ADDENDUM NUMBER 1

**TRI CITIES AIRPORT INDUSTRIAL PARK BPA LIGHTING REPLACEMENT
PROJECT NO. E10-07
January 29, 2010**

BLDG 69 TYPICAL LAYOUT

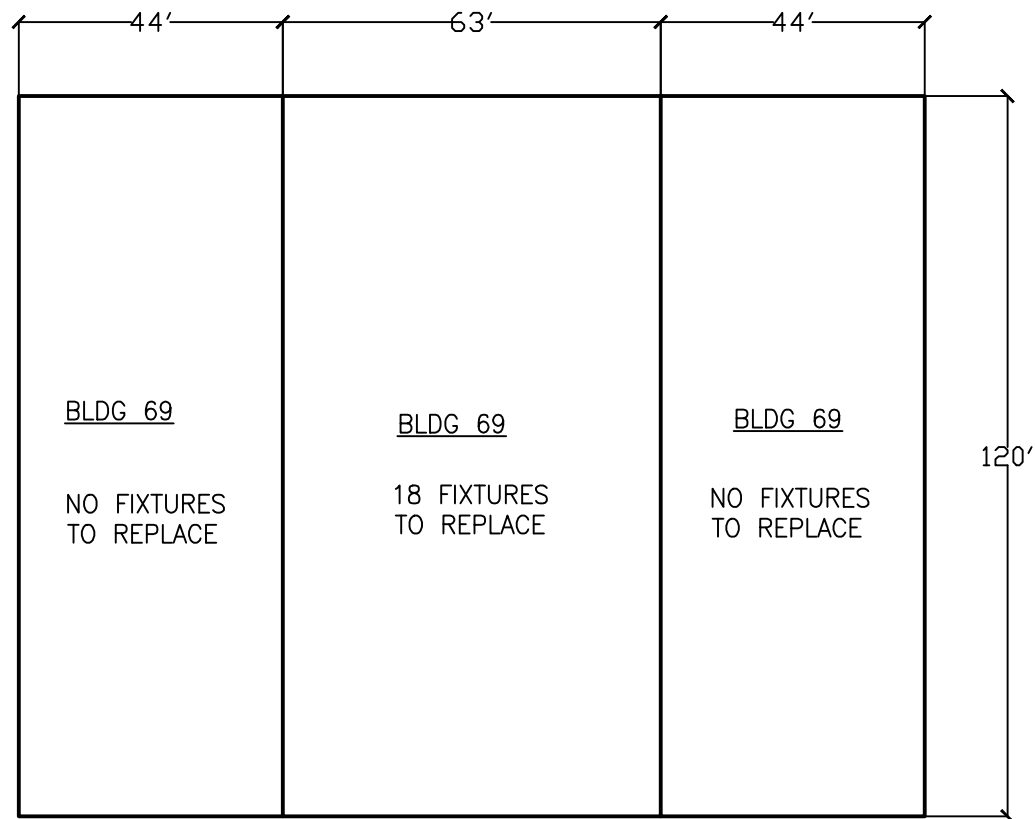
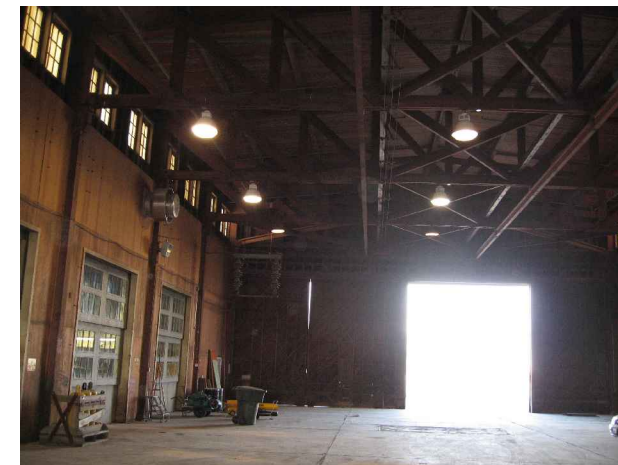
- 4) Add Figure 3- Building 69 to Figures section of bid documents.
